**Addendum No. 2 to IFB #26-46**

To: All Parties on Record with the City of Somerville as Holding IFB #26-46  
Western Pearl Complete Streets

Re: Additional Clarification

**ITEM 701.2**

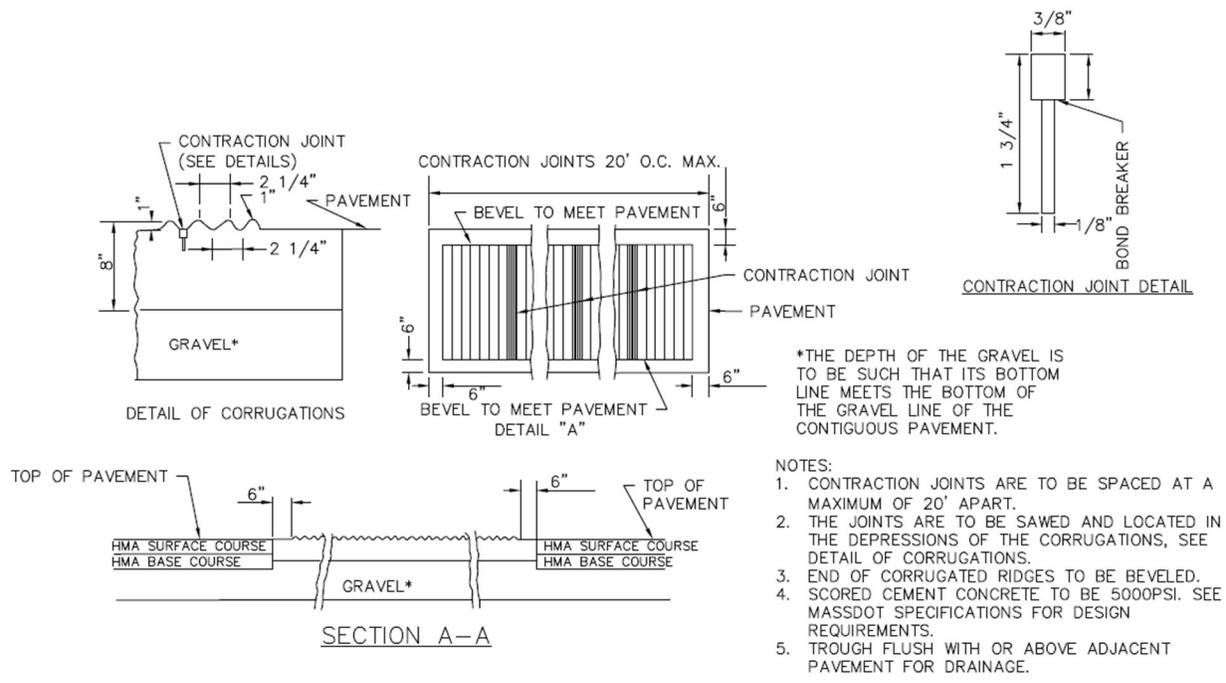
Item 701.5 will require all tactile panels to be unpainted and cast iron. Detectable warning panels quantified in Item 701.5 were measured using the assumption that each warning panel is 2'x5'. The specifications for Items 701.2 and 701.5 have been revised in the attached document, see pages 51 and 61.

Ramps shall be built to the latest specifications of the MassDOT Construction Standard Details and Standard Specifications. Ramps shall include the installation of Detectable Warning Panel in accordance with MassDOT Construction Standard Detail E 107.6.5. **All tactile panels shall be unpainted cast iron.**

**Minimum thickness for Item 701.2 shall be six inches. Windowpane/picture frame finishing shall not be allowed.**
